Government of the District of Columbia
**Advisory Neighborhood
Commission 6C**

January 18, 2021

Re: ZC 14-13E (Text Amendment, Penthouses and Rooftop Structures)

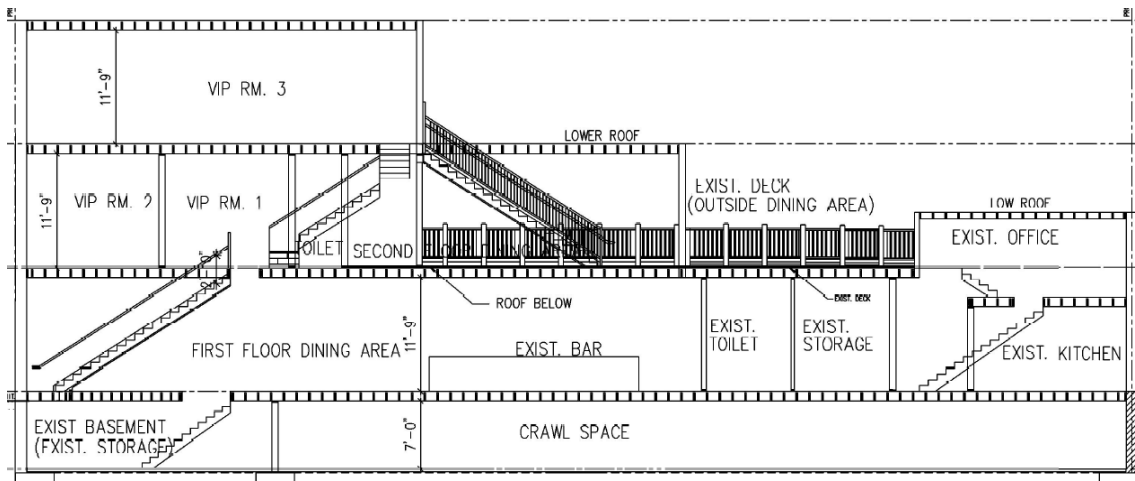
The zoning regulation do not provide a definition for the term “roof,” leading to uncertainty over where the top of a “roof” sits. (The top of the decking? The top of the exterior membrane? Some other point?) OP’s proposed amendments seek to plug this gap in limited circumstances involving green roofs—see new section C-306.7 at page 4—but do not provide a uniform overall standard. Thus, in new section C-306.8 (page 4), penthouse height is to be measured from the “roof” on which the penthouse sits, but it is unclear where that initial measuring point is found.

Complicating this is the fact that comparatively new types of roof assemblies differ in important respects from traditional ones. The most obvious example is that the insulation layer now often sits above the decking, not below it.

- **Recommendation:** add a new definition for “roof” or “top of roof” to clarify the proper measuring point.
